**Seattle
Design
Commission**

**APPROVED
MINUTES OF THE MEETING
19 December 2002**

19 Dec 2002 Project: **South Lake Union Park**

Phase: Conceptual Design

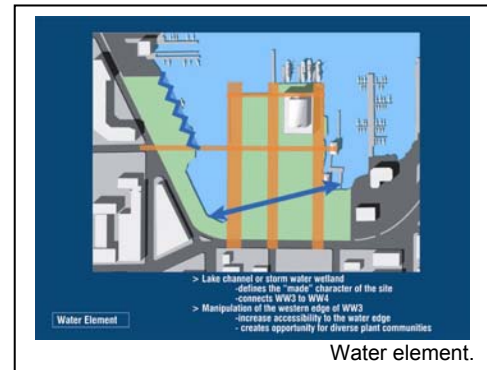
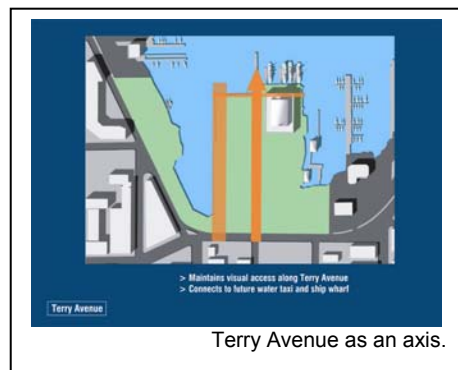
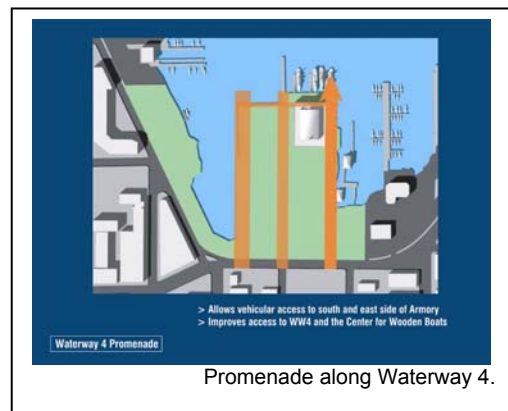
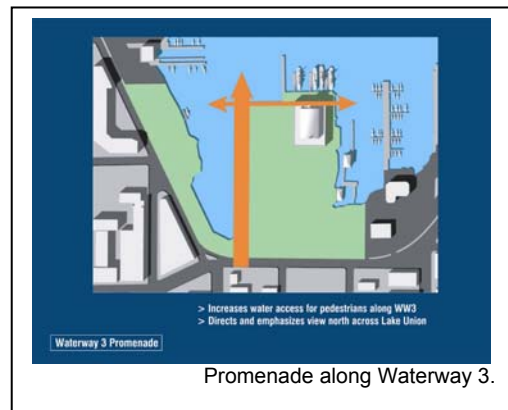
- Would like to know about the geometry of the proposed canal.
 - Proponents stated that nothing specific has been determined at this point. These graphics show diagrammatically the two logical points at the bottom of each waterway being connected.

- Suggests, with hybridizing the concepts of displacement of urban land and natural evolution of land over time, that proponents use a looser geometry than their diagrams show. Feels that the north-south lines are obvious because they are continuous with streets, but other lines could be looser.

- Suggests the possibility of using a grove of native evergreens.
- Is concerned that the north-south lines are wide and thick and the grid is fragmenting the site.

- Proponents stated that the bridge connection is necessary, but whether it is a straight line and what the character of it is at each end has not yet been determined. For the canal, they will use something different from city geometry and it will reflect the geometry of water.

- Proponents stated that they hear the concern for rigidity and width of paves surfaces. The wide streets are merely diagrammatic and are supposed to represent the underlying idea of connections.
